Subject: MHI's Revised Responses to US-APWR DCD RAI No. 286-2145 Revision 1

Revised Responses to Request for Additional Information
No. 286-2145 Revision 1

**US-APWR Design Certification
Mitsubishi Heavy Industries, Ltd.
Docket No. 52-021**

RAI NO.: NO. 286-2145 REVISION 1
SRP SECTION: 9.2.5 – Ultimate Heat Sink
APPLICATION SECTION: 9.2.5
DATE OF RAI ISSUE: 3/25/2009

[Figure 9.2.5-1 Ultimate Heat Sink Flow Diagram (Sheet 1 of 2)]

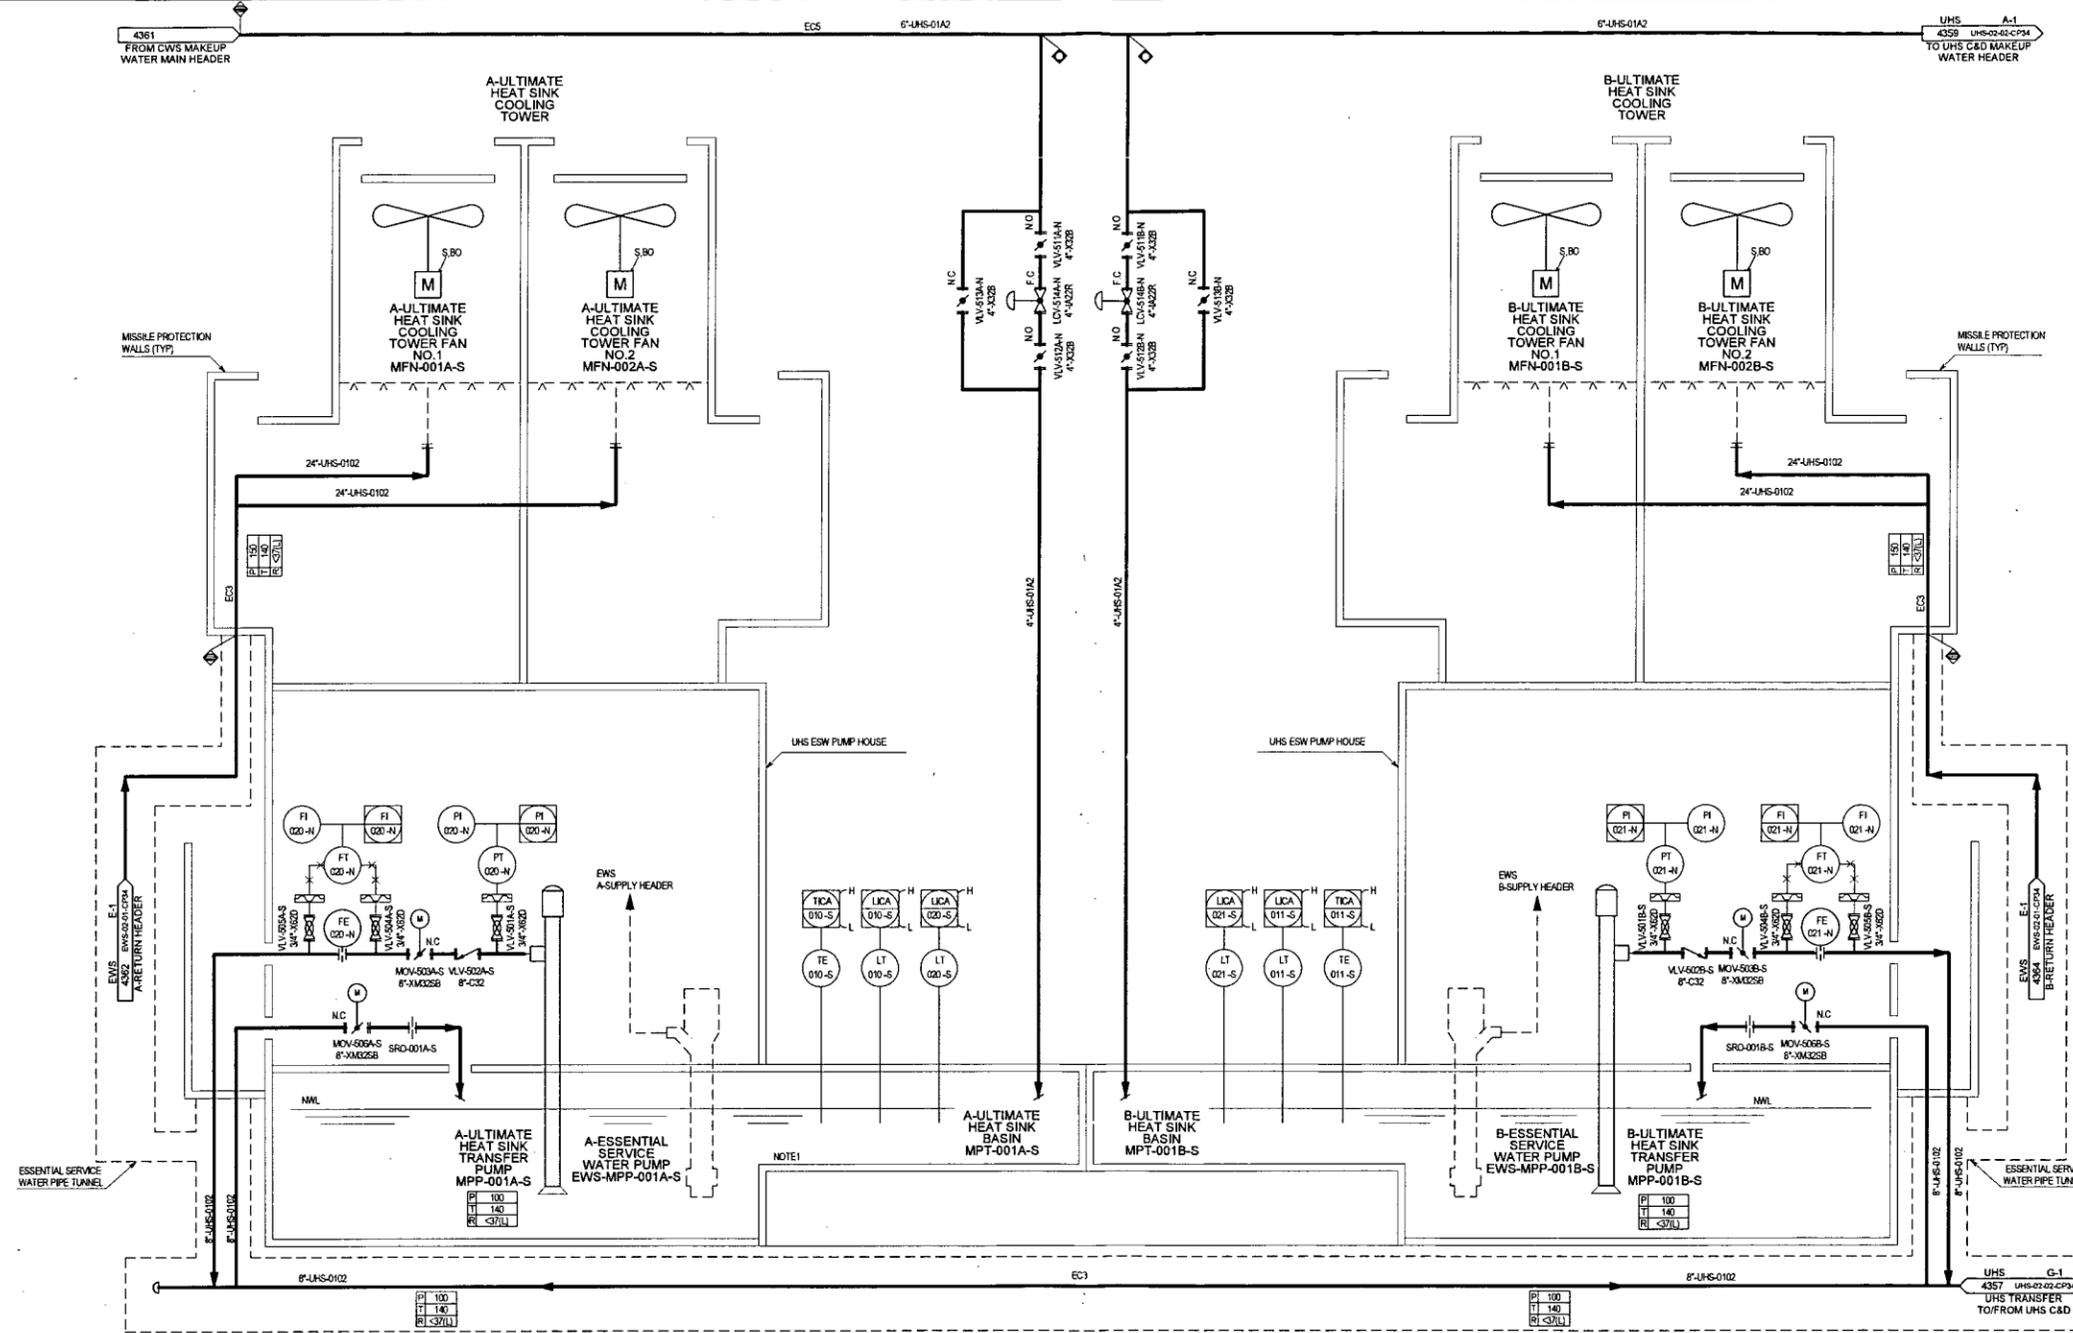
- The UHS flow diagram/drawings should show where indications are displayed (e.g., local, remote panel, control room), and what instruments provide input to a process computer and/or have alarm and automatic actuation functions.

- The UHS flow diagram/drawings should show what the normal valve positions are, what valves are locked in position, and what valves have automatic functions; and these design features are not described.

- The UHS flow diagram/drawings should show any UHS bypass flow rates for low load/low ambient temperature conditions to maintain ESW cold water temperature within established limits.

- If using a UHS with mechanical fans, the UHS fan alarms discussions should be included in the DCD.
 - If using a cooling tower, the UHS flow diagram should show the cooling tower basin instruments (level and temperature).
-

If using a cooling tower, the UHS flow diagram should show the cooling tower basin instruments (level and temperature).

A P&ID representing a conceptual design alternative has been added as DCD Figure 9.2.5-1. Typical pipe sizes are provided in the P&ID using industry standard velocity criteria.

These instruments are shown in new DCD Figure 9.2.5-1.
